Access Assessment Report

711 Hunter Street, Newcastle West NSW 2302

Reference No: 114499-Access-r2

Date: 17 October 2022

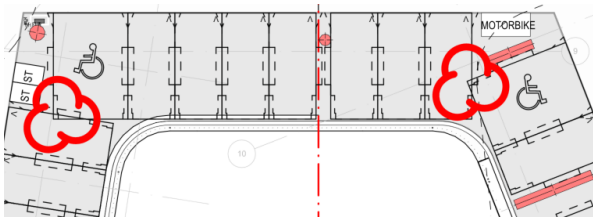
- a) There is a proposal for up to twenty-six (26) private carparking spaces for adaptable SOU residents, distributed across levels 01 to 04 and across DA Stages 1 and 2 of The Development.

However, there is a proposal for a total of 27 adaptable SOUs. As such, there needs to be an allocation of one (1) additional private carparking space for an adaptable SOU that can accommodate minimum 3.8m width by 5.4m length car space in line with AS4299-1999.

Pre-adaptation Stage Layout of Example Unit 1.17.01

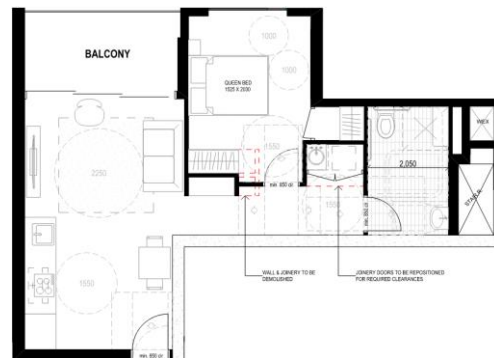
The proposed adaptation strategy for 1 Bedroom Type Adaptable SOU associated with DA Stage 1 of The Development as indicated on drawing PLA-DA-S1-6000 via example unit 1.17.01 generally involves the following minor works and modifications:

- Overall bathroom shell of 2050mm width by approximately 3000mm in length (architect to add exact dimension for the length) appears to be identical between pre-adaptation and post-adaptation stages with exception to the nib wall associated with the vanity being demolished as part of adaptation.
- Pre-adaptation stage vanity carcass and nib wall can readily be detailed (e.g. wall on continuous vertical angles) during detailed design development stages post-DA for ease of adaptation.
- A hob-less shower has been proposed at pre-adaption stage with a glazed shower screen as means separating water from the shower wetting the adjacent toilet pan. The process of modification primarily involves the removal of the shower screen.

The proposed modification can readily meet relevant Performance Requirements of Clause 2.2 of AS4299 – 1995 subject to refining the finer details of the shower screen (e.g. screen installed on continuous vertical angles from outset) to ensure ease of adaptation whilst minimising cost and extent of works (e.g. re-tiling and re-waterproofing tiled wall and/or floor).

- A separate laundry room is not proposed. A laundry cabinet is proposed from pre-adaption stage and maintained in the same location between pre-adaptation and post-adaptation stages. The cabinetry doors can readily be modified (e.g. removed) to accommodate required minimum 1550mm clear diameter turning circle in front of laundry appliances at post-adaptation stages.

Pre-adaptation Stage Floorplan of Example Unit 1.07.06

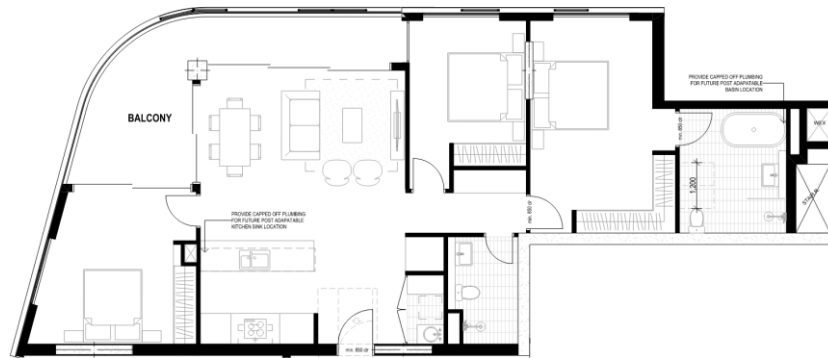
The proposed adaptation strategy for 2 Bedroom Type Adaptable SOU associated with DA Stage 1 of The Development as indicated on drawing PLA-DA-S1-6000 via example unit 1.07.06 generally involves the following minor works and modifications:

NB: It is recommended for the architect to add internal door circulation space dimensions (i.e. minimum 530mm latch-side clearance along minimum 1450mm clear depth for a frontal approach when the door swings towards the user for compliance with AS1428.1-2009) at both pre-adaptation and post-adaptation stage plans.

- Internal corridor appears to achieve minimum 1m in clear width and the architect will need to add all critical clear width dimensions during detailed design development stages post-DA to demonstrate compliance.

- Overall bathroom shell has been dimensioned to achieve 2050mm in width by 2500mm in length and the overall shell appears to be identical between pre-adaptation and post-adaptation stages.
- A hob-less shower has been proposed at pre-adaption stage with a glazed shower screen as means separating water from the shower wetting the adjacent toilet pan. The process of modification primarily involves the removal of the shower screen.

The proposed modification can readily meet relevant Performance Requirements of Clause 2.2 of AS4299 – 1995 subject to refining the finer details of the shower screen (e.g. screen installed on continuous vertical angles from outset) to ensure ease of adaptation whilst minimising cost and extent of works (e.g. re-tiling and re-waterproofing tiled wall and/or floor).

- A separate laundry room is not proposed. A laundry cabinet is proposed from pre-adaption stage and maintained in the same location between pre-adaptation and post-adaptation stages. The cabinetry doors can readily be modified (e.g. removed if and when required) to accommodate required minimum 1550mm clear diameter turning circle directly in front of laundry appliances at post-adaptation stages.

- The kitchen at pre-adaption stage consists of L-shaped bench with a cooktop and sink with a recessed area for a fridge. This layout stays exactly the same at post-adaptation stage and can accommodate minimum 1550mm clear diameter turning circle between kitchen appliances.

Pre-adaptation Stage Floorplan of Example Unit 1.18.05

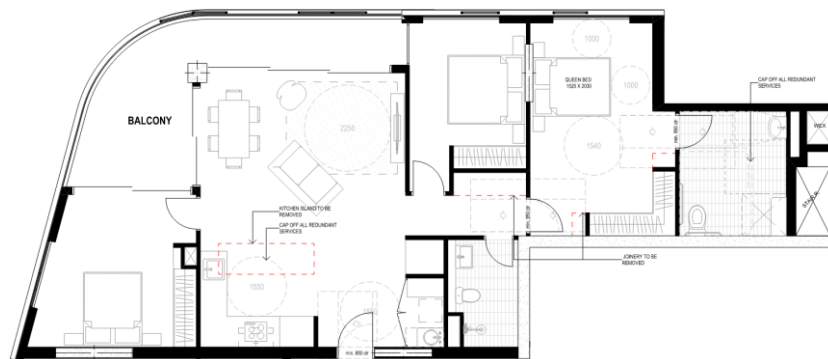
The proposed adaptation strategy for 3 Bedroom Type Adaptable SOU associated with DA Stage 1 of The Development as indicated on drawing PLA-DA-S1-6001 via example unit 1.18.05 generally involves the following minor works and modifications:

NB: It is recommended for the architect to add internal door circulation space dimensions (i.e. minimum 530mm latch-side clearance along minimum 1450mm clear depth for a frontal approach when the door swings towards the user for compliance with AS1428.1-2009) at both pre-adaptation and post-adaptation stage plans.

- Internal corridor appears to achieve minimum 1m in clear width and the architect will need to add all critical clear width dimensions during detailed design development stages post-DA to demonstrate compliance.

- Adaptable bathroom's shell appears to be sufficient in overall room dimensions (architect to add exact dimensions in terms of width and length) and identical between pre-adaptation and post-adaptation stages.
- The pre-adaption stage bathroom has a vanity with inbuilt basin and a free-standing bathtub that is provided from outset. These sanitaryware are removed as part of the process of adaptation allowing the resident to install an accessible basin for compliance with AS1428.1-2009 without encroaching into required minimum circulation spaces for the shower recess and toilet pan.

- A hob-less shower has been proposed at pre-adaption stage with a glazed shower screen as means separating water from the shower wetting the adjacent basin. The process of modification primarily involves the removal of the shower screen and the re-orientation of the shower.

The proposed modification has the potential to meet relevant Performance Requirements of Clause 2.2 of AS4299 – 1995 subject to refining the finer details of the shower screen (e.g. glass screen enclosure and swing door installed on continuous vertical angles from outset) to ensure ease of adaptation whilst minimising cost and extent of works (e.g. re-tiling and re-waterproofing tiled wall and/or floor) and provision of capped off services from outset for the shower re-orientation to comply with AS1428.1-2009 at post-adaptation stage.

- A separate laundry room is not proposed. A laundry cabinet is proposed from pre-adaption stage and maintained in the same location between pre-adaptation and post-adaptation stages. The cabinetry doors can readily be modified (e.g. removed if and when required) to accommodate required minimum 1550mm clear diameter turning circle directly in front of laundry appliances at post-adaptation stages.

At post-adaption stage the kitchen is modified to be a continuous L-shaped bench with the sink relocated to accommodate minimum 1550mm clear diameter turning circle in front of the sink and cook top.

Pre-adaptation Stage Floorplan of Example Unit 2.01.01

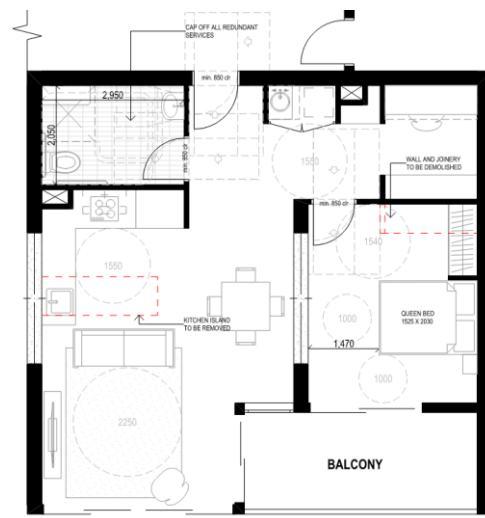
The proposed adaptation strategy for 1 Bedroom Type Adaptable SOU associated with DA Stage 2 of The Development as indicated on drawing PLA-DA-S2-6000 via example unit 2.01.01 generally involves the following minor works and modifications:

NB: It is recommended for the architect to add internal door circulation space dimensions (i.e. minimum 530mm latch-side clearance along minimum 1450mm clear depth for a frontal approach when the door swings towards the user for compliance with AS1428.1-2009) at both pre-adaptation and post-adaptation stage plans.

- Internal corridor appears to achieve minimum 1m in clear width and the architect will need to add all critical clear width dimensions during detailed design development stages post-DA to demonstrate compliance.

- Overall bathroom shell has been dimensioned to achieve 2050mm in width by 2950mm in length and the overall shell appears to be identical between pre-adaptation and post-adaptation stages.
- A hob-less shower has been proposed at pre-adaption stage with a glazed shower screen as means separating water from the shower wetting the toilet pan. The process of modification primarily involves the removal of the shower screen.

The proposed modification can readily meet relevant Performance Requirements of Clause 2.2 of AS4299 – 1995 subject to refining the finer details of the shower screen (e.g. glass screen continuous vertical angles from outset) to ensure ease of adaptation whilst minimising cost and extent of works (e.g. re-tiling and re-waterproofing tiled wall and/or floor).

- A separate laundry room is not proposed. A laundry cabinet is proposed from pre-adaption stage and maintained in the same location between pre-adaptation and post-adaptation stages. The cabinetry doors can readily be modified (e.g. removed if and when required) to accommodate required minimum 1550mm clear diameter turning circle directly in front of laundry appliances at post-adaptation stages.

- The kitchen at pre-adaption stage consists of two (2) separate parallel benches with a cooktop on one bench and a sink on the remaining bench with a recessed area for a fridge. There are provisions for capped off plumbing services from outset for future sink relocation.

At post-adaption stage the kitchen is modified to be a continuous L-shaped bench with the sink relocated to accommodate minimum 1550mm clear diameter turning circle in front of the sink and cook top.

Pre-adaptation Stage Floorplan of Example Unit 2.14.05

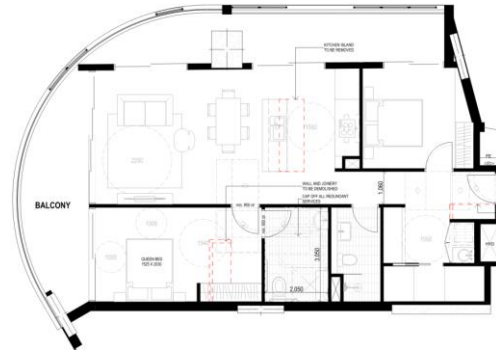
The proposed adaptation strategy for 2 Bedroom Type Adaptable SOU associated with DA Stage 2 of The Development as indicated on drawing PLA-DA-S2-6001 via example unit 2.14.05 generally involves the following minor works and modifications:

- Unit entry doorway is detailed with minimum 850mm clear opening width from outset and maintained to post-adaptation stage.
- Post-adaptation stage modification will involve demolition of light construction wall and joinery item to accommodate the required internal door circulation space when the door swing towards the user for compliance with AS1428.1-2009.

- Overall bathroom shell has been dimensioned to achieve 2050mm in width by 2950mm in length and the overall shell appears to be identical between pre-adaptation and post-adaptation stages.
- A hob-less shower has been proposed at pre-adaption stage with a glazed shower screen as means separating water from the shower wetting the toilet pan. The process of modification primarily involves the removal of the shower screen.

The proposed modification can readily meet relevant Performance Requirements of Clause 2.2 of AS4299 – 1995 subject to refining the finer details of the shower screen (e.g. glass screen continuous vertical angles from outset) to ensure ease of adaptation whilst minimising cost and extent of works (e.g. re-tiling and re-waterproofing tiled wall and/or floor).

- A separate laundry room is not proposed. A laundry cabinet is proposed from pre-adaption stage and maintained in the same location between pre-adaptation and post-adaptation stages. The cabinetry doors can readily be modified (e.g. removed if and when required) to accommodate required minimum 1550mm clear diameter turning circle directly in front of laundry appliances at post-adaptation stages.

- Due to the open plan of the living area, loose furniture items can readily and easily be relocated to accommodate minimum 2250mm clear diameter turning circle as required.
